UNITED STATES PATENT AND TRADEMARK OFFICE

APPLICATION NO.	FILING DATE	FIRST NAMED INVENTOR	ATTORNEY DOCKET NO.	CONFIRMATION NO.
10/736,411	12/15/2003	James W. Nicholson	P1682 US (2650/191)	3962

Office Action Summary	Application No.	Applicant(s)	
	10/736,411	NICHOLSON ET AL.	
	Examiner	Art Unit	
	Tuan V. Nguyen	3731

DETAILED ACTION

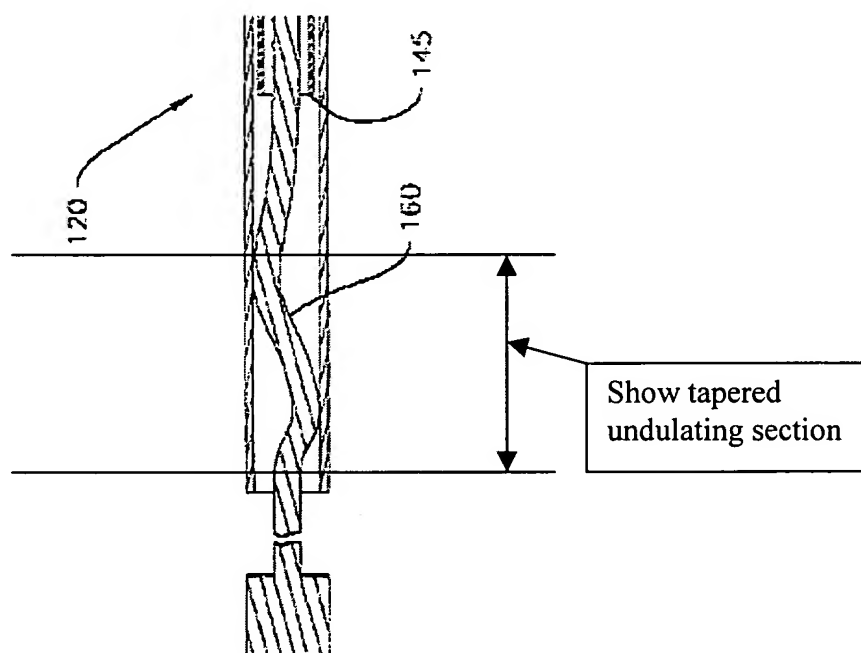
6. Referring to **claim 1**, Douk et al disclose a system for treating a vascular condition (see Figs. 4 and 5), the system comprising: a hollow Guidewire 144; a core wire 142 inserted through the hollow guidewire, the core wire including a tapered undulating section 160 (see an exact copy of Fig. 13 attached below this paragraph that further clarify the tapered undulating section) carried within the hollow guidewire; and an embolic filter device 25 or occluder device 320 (see Fig.13 and col. 8, lines 54-55) coupled between a distal end 27 of the hollow guidewire and a distal end 48 of the core wire, wherein the undulating section 160 of the core wire provides frictional control of the embolic containment device based on a direction of axial translation within the hollow guidewire. The undulating section 160 is frictionally contacted an inner surface of the hollow guidewire (see col 4, line 11 to col 5, line 53). With respect to the limitation “wherein the tapered undulating section provides a different amount of friction when the core wire translates in the first direction than when the core wire translates in the second direction”. Douk does not explicitly disclose the response to the effect of the tapered design, however, Douk discloses the structure as claimed in applicant’s invention. It has been held that it is elementary that the mere recitation of a newly discovered function or property, inherently possessed by things in the prior art, does not cause a claim drawn to distinguish over the prior art. Additionally, where
